COBRA Guidance Note

Some users have been reporting bulging of the COBRA demand valve diaphragm alongside difficulty setting the positive pressure.

Figure 1 - Diaphragm Resting Shape

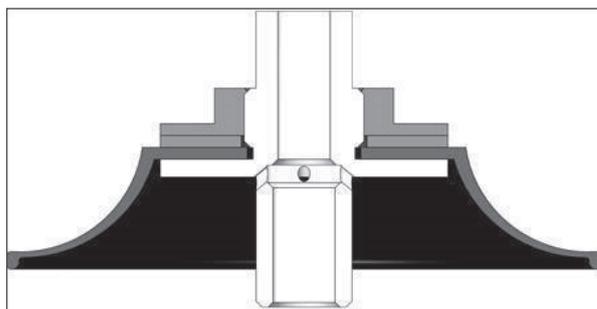
1. Firstly, it is necessary to determine whether the diaphragm is actually bulging or merely sitting asymmetrically. Bulging is defined as having any protrusion beyond the shape developed by the diaphragm when the set is in standby mode and gas is venting from the external relief valves (due to lightly purging the demand valve). If any bulging is evident, the diaphragm must be replaced.

Figure 3 - Acceptable Asymmetric Shape

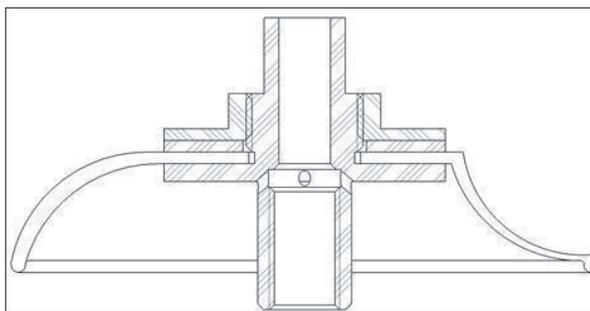
If the diaphragm is sitting asymmetrically, this is not a problem in its own right. If a stable positive pressure can be achieved, it is perfectly acceptable to use the COBRA set. In use, the diaphragm is clamped at the circumference and pulled down in the centre. Depending on the inherent stiffness of the individual diaphragm, the positive pressure acting on the underside of the diaphragm may or may not be sufficient to cause the flexible section of the diaphragm between the edge and the centre to adopt a fully convex shape.
